REGIONAL REVIEW FINDING

ARC REVIEW CODE: R1607141

Name of Proposal: Destinations at Mall of Georgia (DRI #2574)

Submitting Local Government: Gwinnett County

SITE

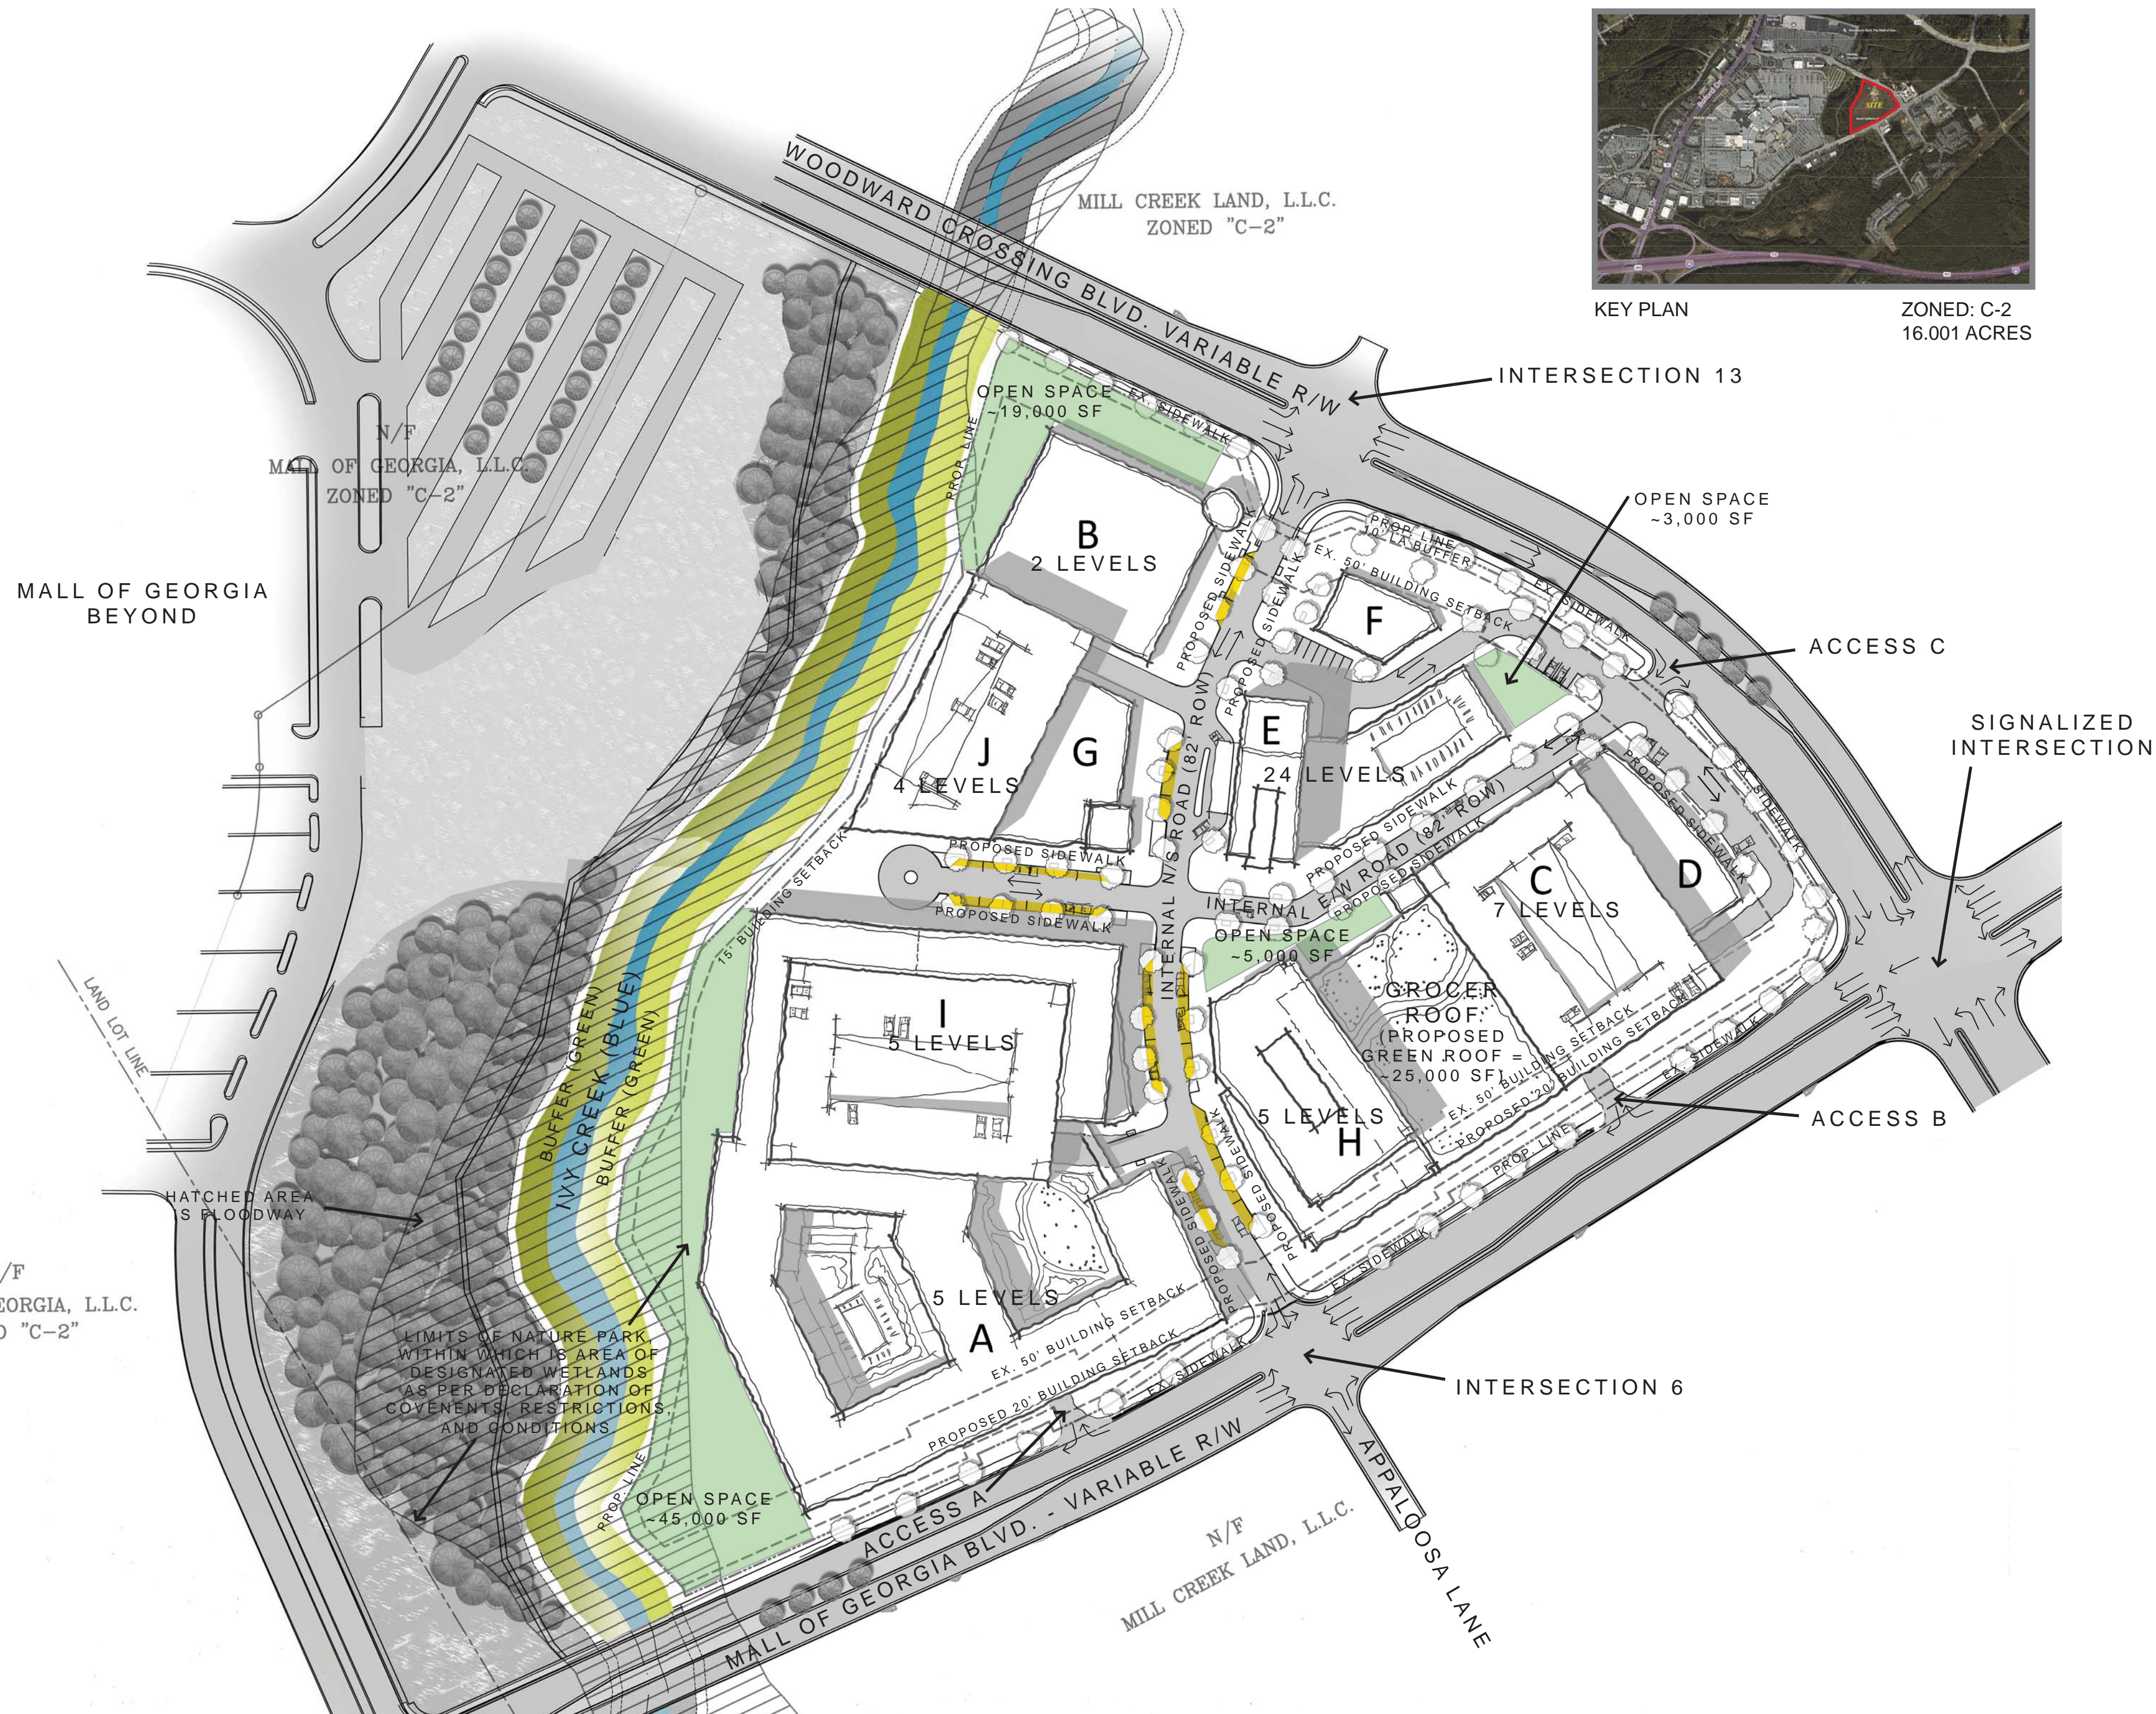
The site is bounded on two sides by existing roadways. The third side of the triangular site is Ivy Creek. The parcel on the other side of the creek is not conducive to large scale development, so a roadway connection would not be practical.

The site is proposed to be connected to the Mall of Georgia via a pedestrian bridge over Ivy Creek. This bridge should also be constructed to accommodate bicyclists using the Ivy Creek Greenway, particularly in the event that the trail in this area is paved in the future.

A small grocery store and some retail space is proposed, but the size is not likely to generate a significant amount of truck traffic. However, it is unclear from the site plan where trucks would service those businesses without blocking internal drives and/or sidewalks.
